CIP 726 STREET REHABILITATION PROJECT 2025-26

Questions Received Via Email

ATTACHMENT 1: UTILITIES MAP – WATER AND SEWER

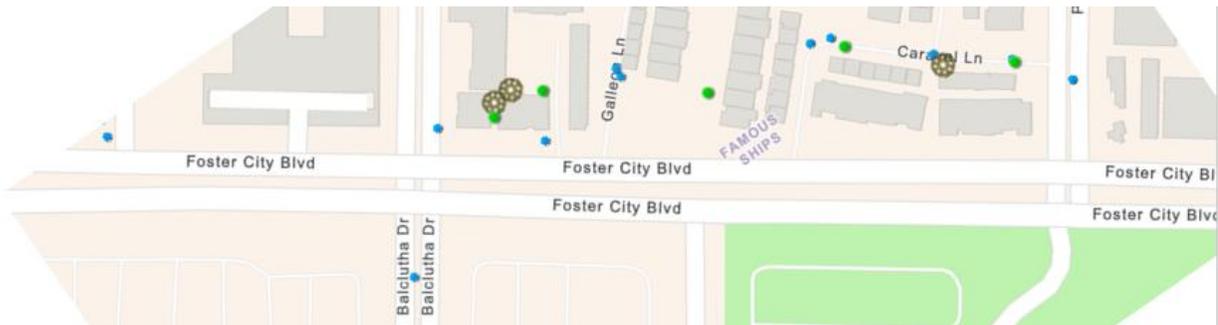
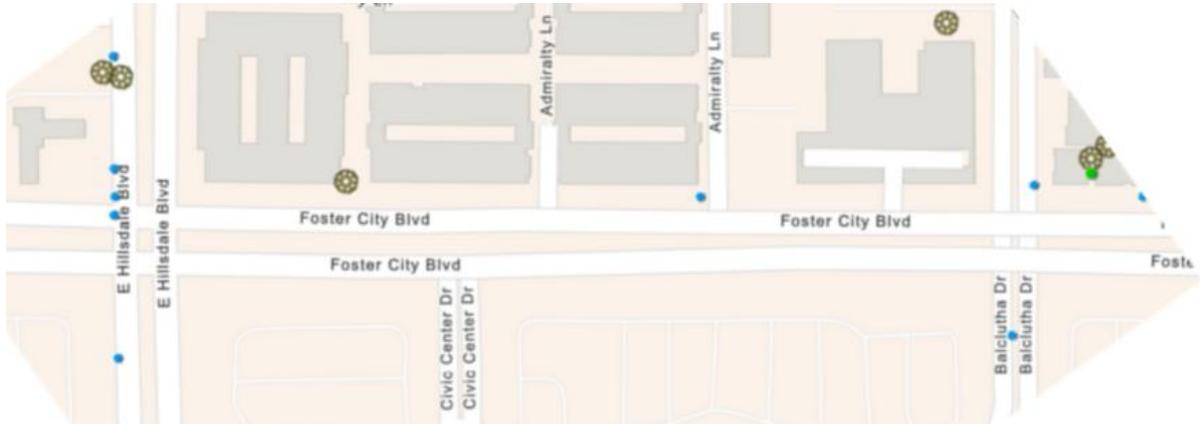
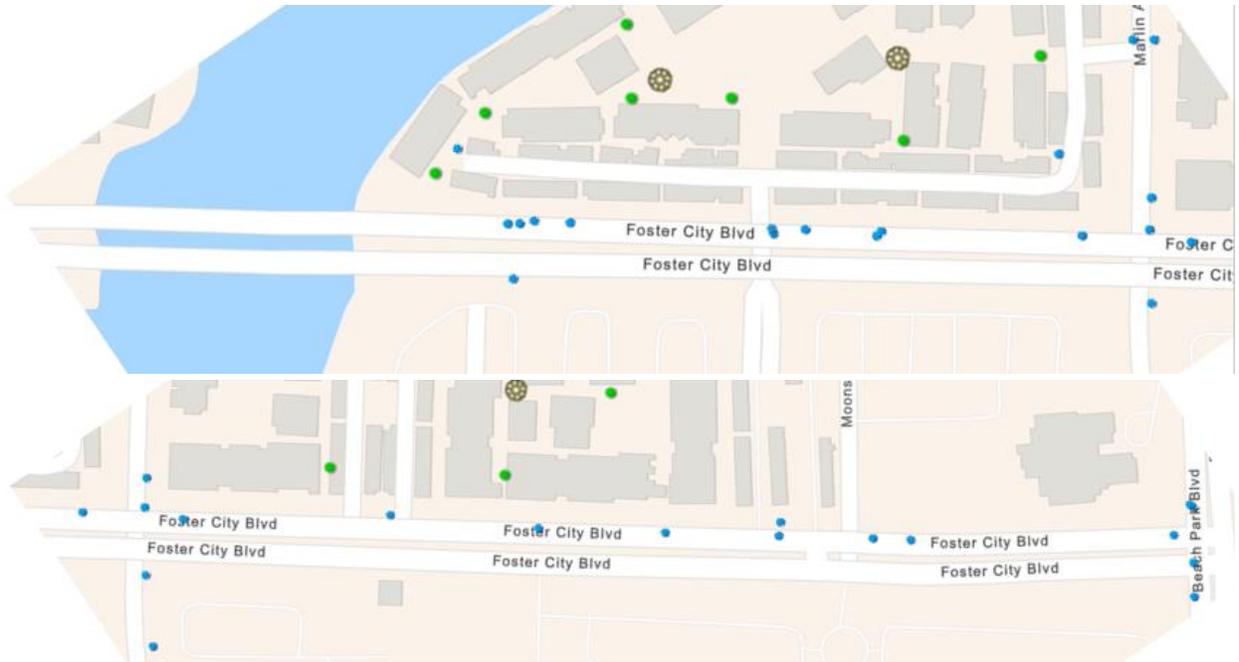
1. Confirm description for Bid Alternate 1, Line item 4A.
 - a. Please refer to the updated Bid Schedule in Addendum 1.
2. Request for utility and monument counts.

- b. Please refer to Attachment 1 for water valves and sewer manholes. Locations are approximate and the City is not responsible for erroneous information.
